FINAL DRAINAGE REPORT FOR THE VILLAS AT CLAREMONT RANCH

July 2022

PCD NO. SF-22-028

V4_Drainage Report - Final.pdf Markup Summary

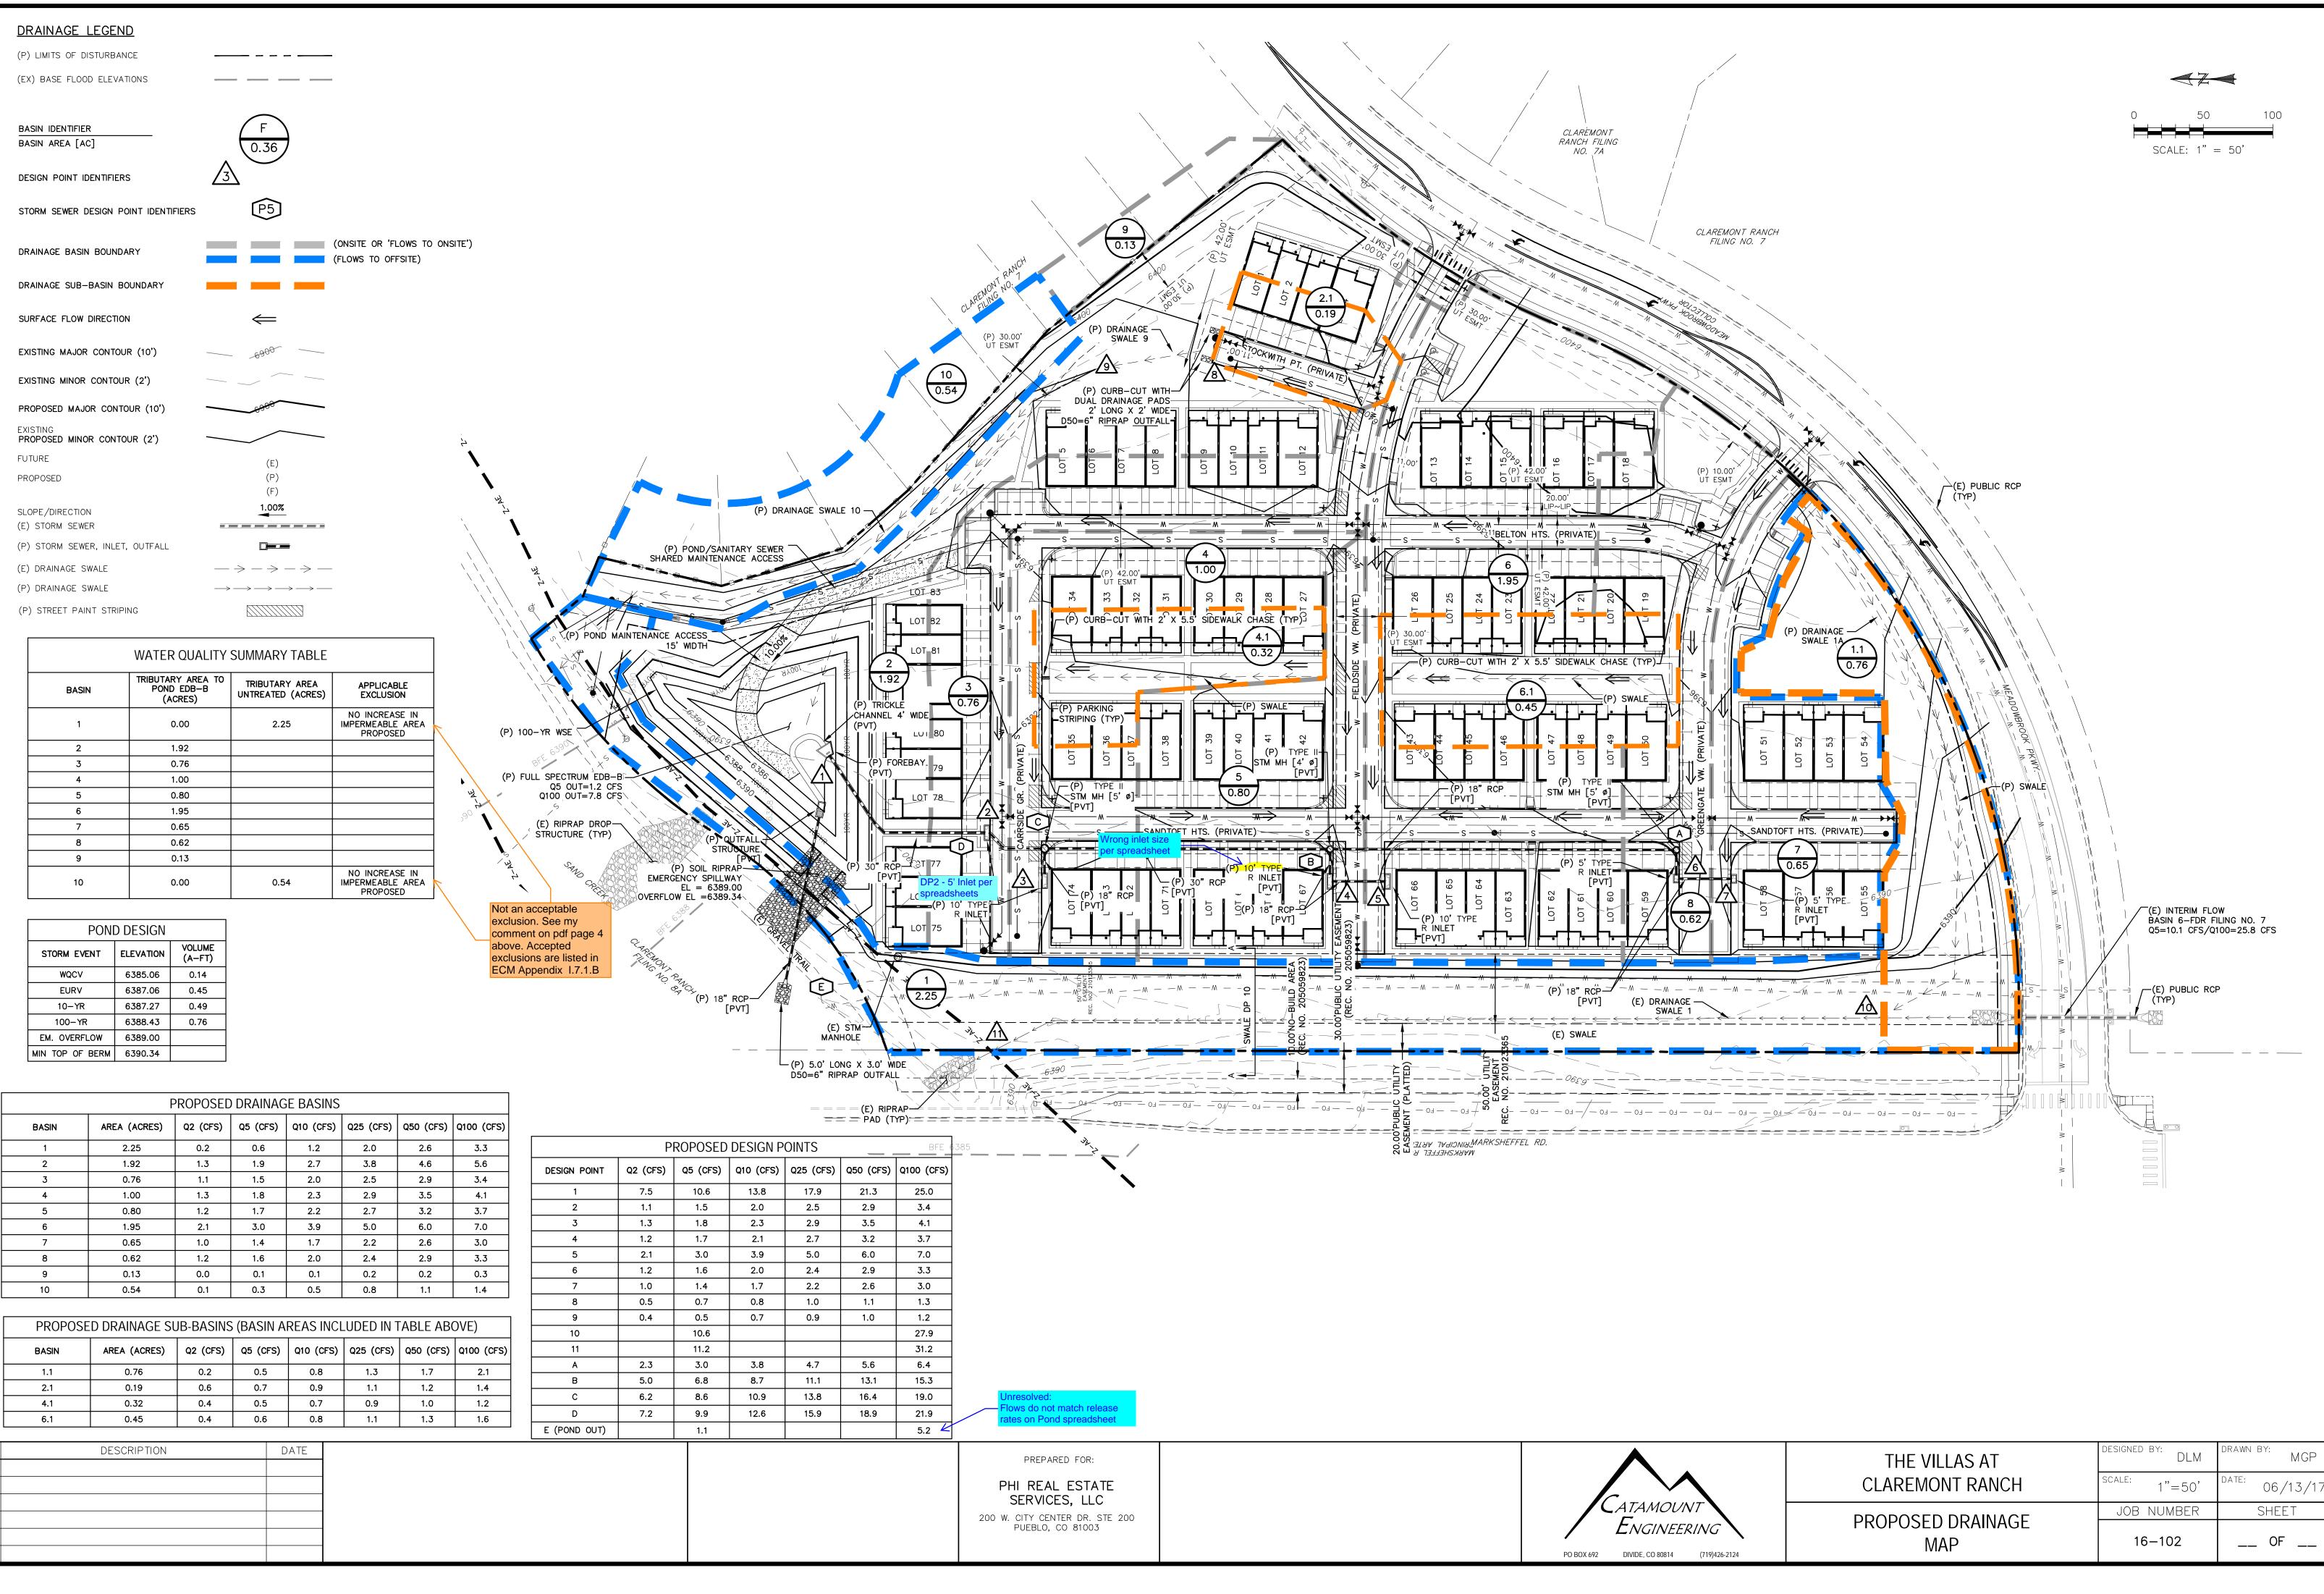
Subject: SW - Textbox with Arrow Page Label: 83 Author: Glenn Reese - EPC Stormwater Date: 3/29/2023 3:34:23 PM Status: Color: Layer: Space: Unresolved Review #3 comment: State which WQ treatment exclusion applies to this basin. Review #4 clarification: WQ treatment is required for all soil disturbances, not just for impervious surfaces, unless a WQ exclusion applies. Thus state which WQ exclusion you believe applies to Basins 1, 1.1, and 10.

Not an acceptable exclusion. See my comment on pdf page 4 above. Accepted exclusions are listed in ECM Appendix 1.7.1.B
